Pinout of Driver Control

Subject:

Airgap switch resistances.jpg; airgap op amp feedback resistance.jpg Attached Schematics with updated resistance

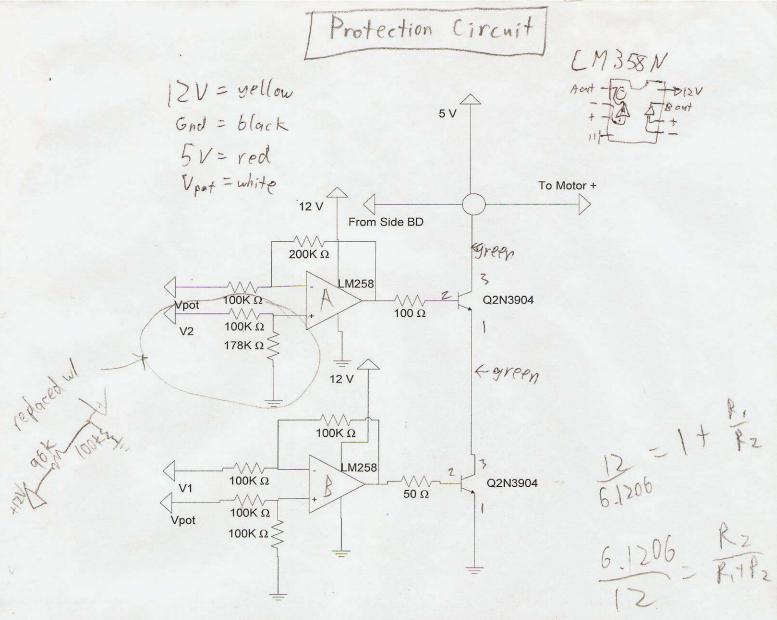
1: TODO for next design
2: implemented - fixed the issue
of burning the box (overheat
when 1+3 both slightly on)

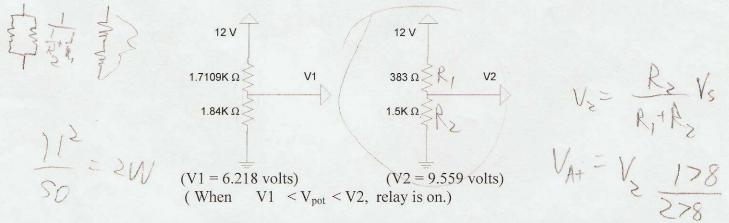
This is the simulation of the protection circuit. Outside 6.9 V - 8.8 V, the relay will shut off and subsequently shut off the air-gap motor. (?????? Ranges are different from selected V1 and V2)
